UNITED STATES
NUCLEAR REGULATORY COMMISSION
WASHINGTON, D. C. 20555
June 12, 1980

The Commission has issued the enclosed Amendments Nos. 83, 83, and 80 for Licenses Nos. DPR-38, DPR-47 and DPR-55 for the Oconee Nuclear Station, Units Nos. 1, 2 and 3. These amendments consist of changes to the operating licenses and the Station's common Technical Specifications in response to your request dated September 22, 1976, as supplemented September 11, 1979, and your request dated November 16, 1979, as superseded March 12, 1980 and supplemented April 30, 1980.

These amendments revise the Technical Specifications to support the operation of Oconee Unit No. 2 at full rated power during Cycle 5. The amendments also incorporate monitoring conditions for secondary water chemistry in the body of the licenses for Units Nos. 1, 2 and 3 in response to your request dated September 11, 1979, and staff discussions.

OCONEE NUCLEAR STATION, UNITS NOS. 1, 2 AND 3

Figure 2.1-2B

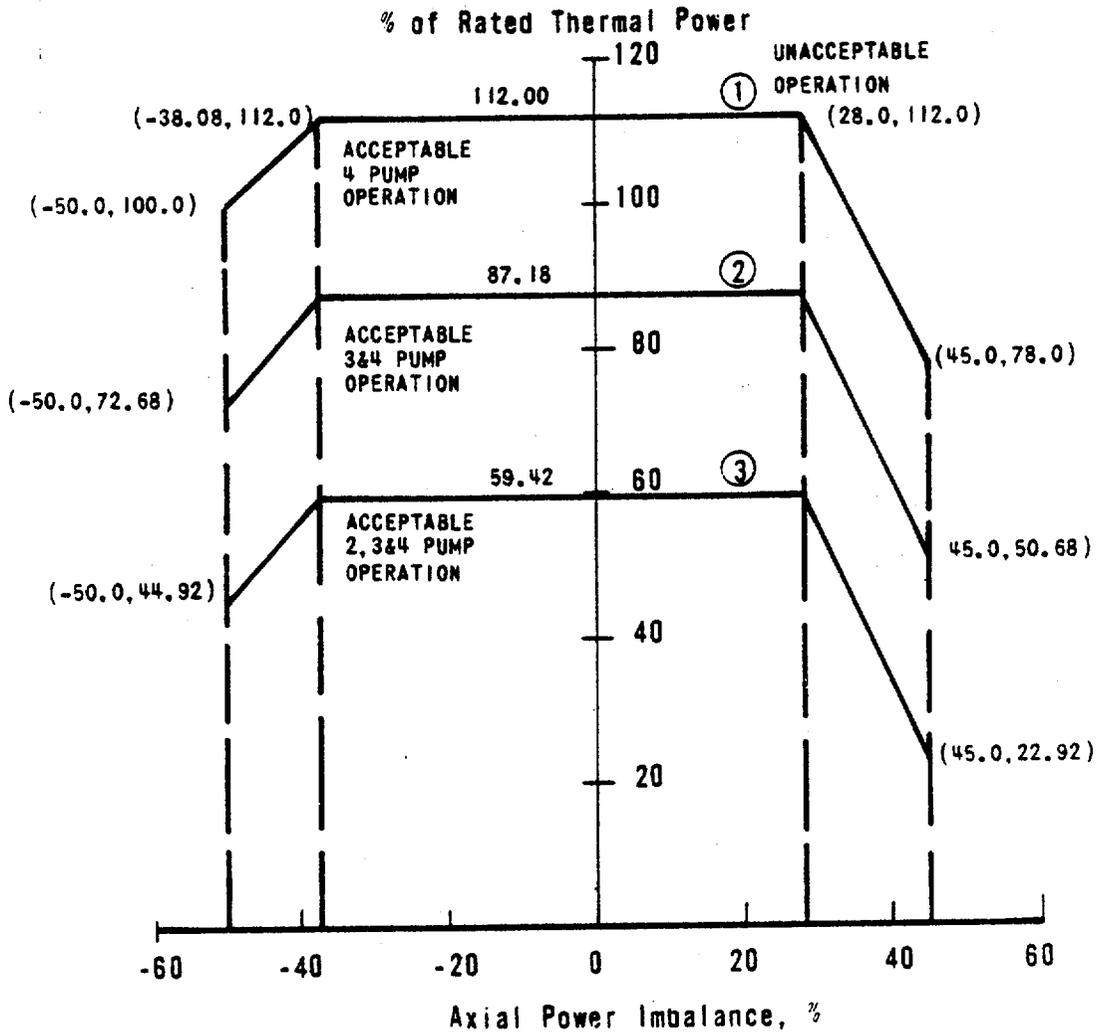
The specified flow rates for Curves 1, 2, and 3 of Figure 2.1-2B correspond to the expected minimum flow rates with four pumps, three pumps, and one pump in each loop, respectively.

CURVE	REACTOR COOLANT FLOW (GPM)
1	374,880
2	280,035
3	183,690

ROD POSITION LIMITS
FOR FOUR-PUMP OPERATION
FROM 0 TO 150 ± 10 EFPD
UNIT 2
OCONEE NUCLEAR STATION
Figure 3.5.2-1B1

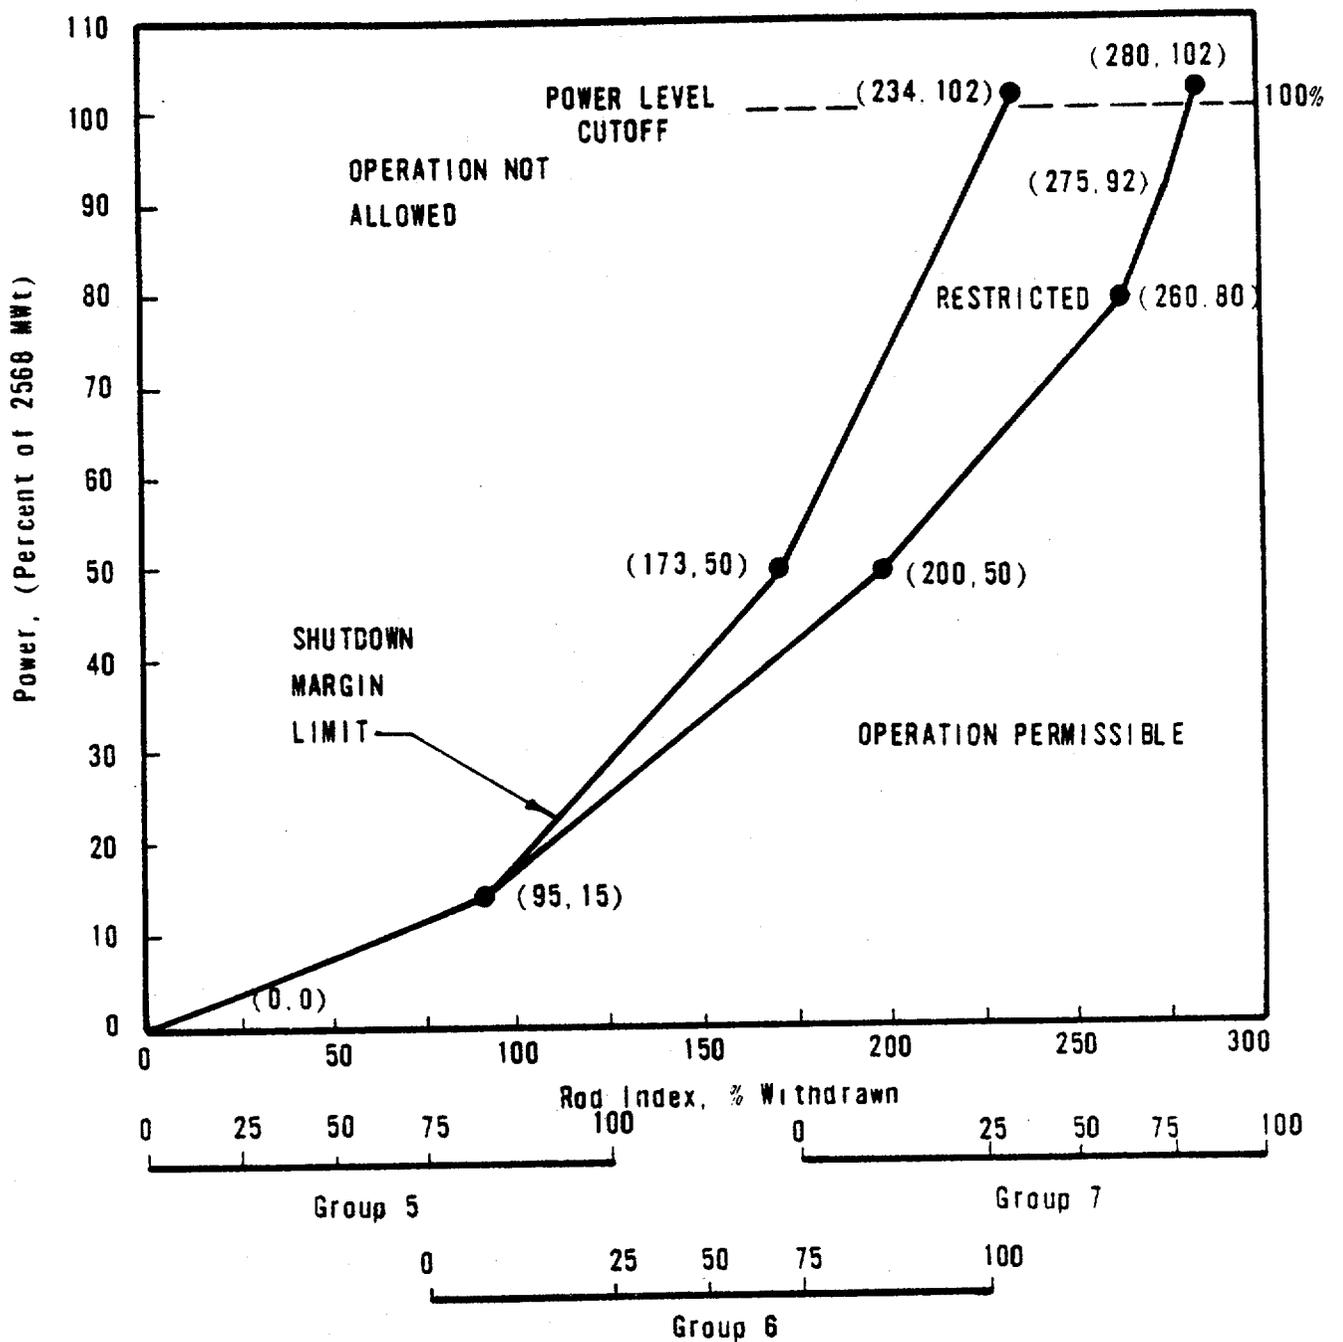
- c. Axial power shaping rod position limits for less than 150 EFPDs and for more than 150 EFPDs.
- d. Operational power imbalance limits for 0 to 360 EFPDs.
